UNITED STATES PATENT AND TRADEMARK OFFICE

APPLICATION NO.	FILING DATE	FIRST NAMED INVENTOR	ATTORNEY DOCKET NO.	CONFIRMATION NO.
10/565,892	01/24/2006	William David Lewis	024774556	7925
24978	7590	08/14/2007		
GREER, BURNS & CRAIN 300 S WACKER DR 25TH FLOOR CHICAGO, IL 60606			EXAMINER O HERN, BRENT T	
			ART UNIT 1772	PAPER NUMBER
			MAIL DATE 08/14/2007	DELIVERY MODE PAPER

Office Action Summary	Application No. 10/565,892	Applicant(s) LEWIS ET AL.	
	Examiner Brent T. O'Hern	Art Unit 1772

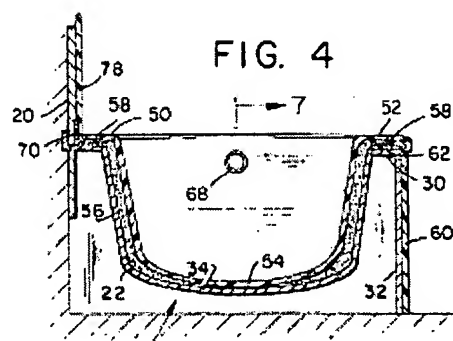
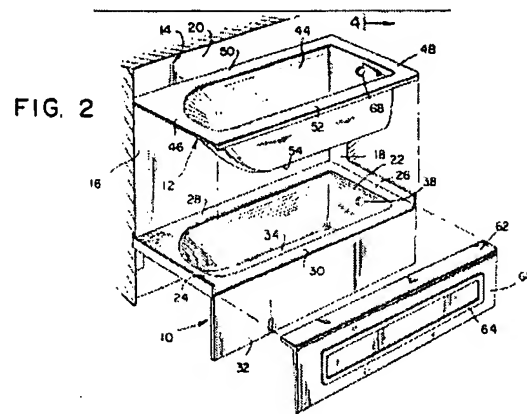
7. Claim 63 is rejected under 35 U.S.C. 112, second paragraph, as being indefinite for failing to particularly point out and distinctly claim the subject matter which applicant regards as the invention.

Claim 63 recites the limitation "said ... lower members" in lines 4-5. There is insufficient antecedent basis for this limitation in the claim.

Clarification and/or correction is required.

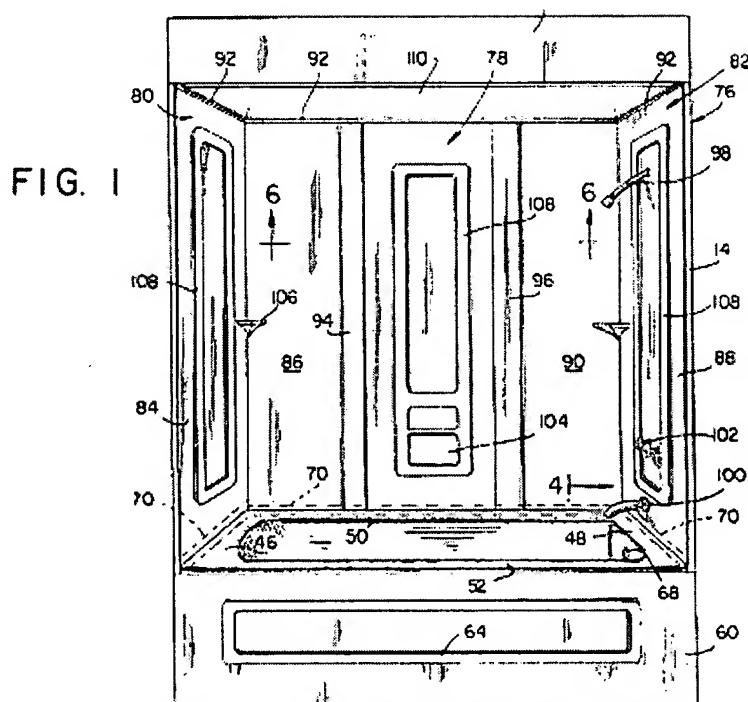
Regarding claims 46-47, Altman ('071) teaches wherein the upper member is an acrylic capped acrylonitrile butadiene styrene material (*col. 4, ll. 12-23*). Furthermore, Applicant has not precisely positively set forth an acrylic layer.
